Proposal for the 06 Series of Amendments to UN Regulation No. 95 (Lateral impact)

Submitted by the expert from OICA

The text reproduced below was prepared by the expert from the International Organization of Motor Vehicle Manufacturers (OICA). It replaces ECE/TRANS/WP.29/GRSP/2023/18 to resolve editorial issues. The proposal aims to introduce requirements for the post-crash safety of hydrogen-fuelled vehicles based on the Amendment 1 to UN GTR No. 13 (Hydrogen and Fuel Cells Vehicles). The modifications to the current text of the UN Regulation are marked in bold for new characters and the modifications from ECE/TRANS/WP.29/GRSP/2023/18 are given in red fonts.

Figure 2a

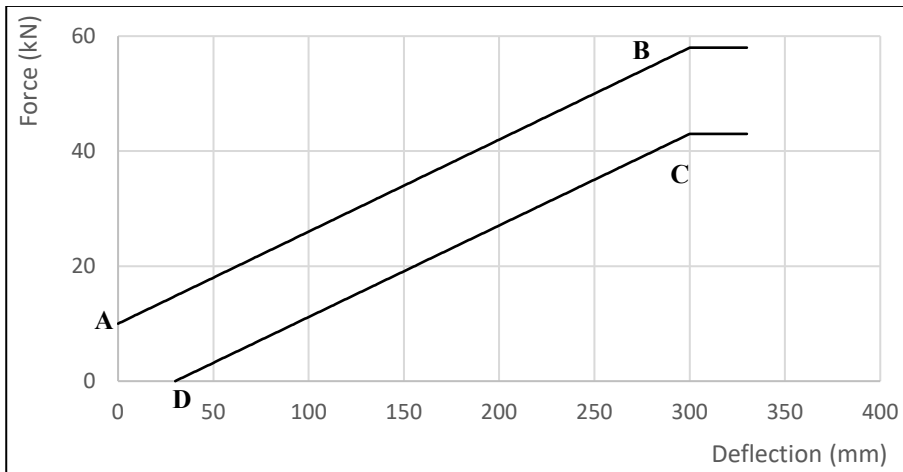
Annex 5 – Appendix 2, amend to read:

FORCE-DEFLECTION CURVES FOR DYNAMIC TESTS

Deflection	Force
A	0 mm	10 kN
B	300 mm	58 kN
C	300 mm	43 kN
D	30 mm	0 kN
